Title of Change:	D2PAK Case Outline Standardization from 418B-04 to 418AJ for all effected devices manufactured in On Semiconductor Seremban, On Semiconductor Vietnam and TFME facility.
Effective date:	14 July 2019
Contact information:	Contact your local ON Semiconductor Sales Office or <Norsahida.sahman@onsemi.com>
Type of notification:	This Product Bulletin is for notification purposes only. ON Semiconductor will proceed with implementation of this change upon publication of this Product Bulletin.
Change Category:	☐ Wafer Fab ☐ Assembly Change ☐ Test Change ☒ Other Case Outline

ON Semiconductor is migrating the D2PAK discrete package case outline from version 418B-04 to version 418AJ. The change impacts the Rectifier, BJT and MOSFET product lines. This transition allows ON Semiconductor to standardize its significantly increased portfolio on a single case outline.

D²PAK 3
CASE 418B-04
ISSUE L

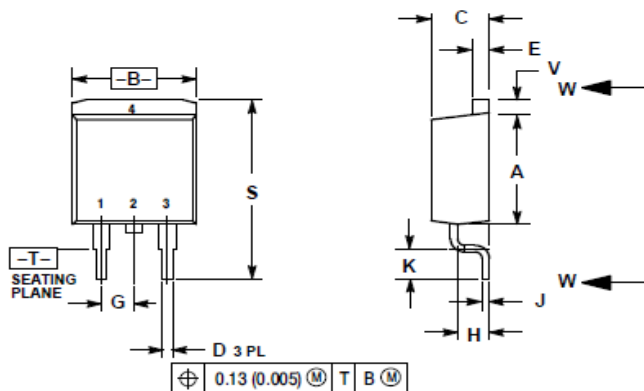
This notification does not represent a change to existing materials, tools or processes used to manufacture the affected devices. The new case outline, 418AJ, is consistent with JEDEC dimensional guidelines for the D2PAK.

D²PAK 3
CASE 418B-04
ISSUE L

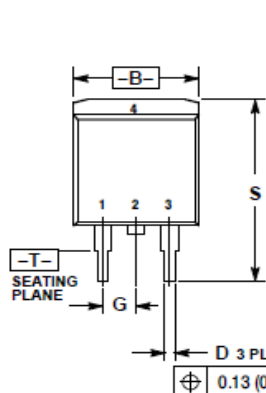
オン・セミコンダクターは、D2PAK ディスクリットパッケージのケースアウトラインを、バージョン 418B-04 からバージョン 418AJ に移行します。この変更は、整流器、BJT、および MOSFET 製造ラインに影響を与えます。この移行により、オン・セミコンダクターは統一されたケースアウトラインに基づいて、大幅に増大したポートフォリオを標準化できます。

この通知は、対象製品の製造に使用される既存の材料、ツール、またはプロセスへの変更を意味するものではありません。新しいケースアウトラインの 418AJ は、D2PAK の JEDEC 寸法ガイドラインに適合しています。
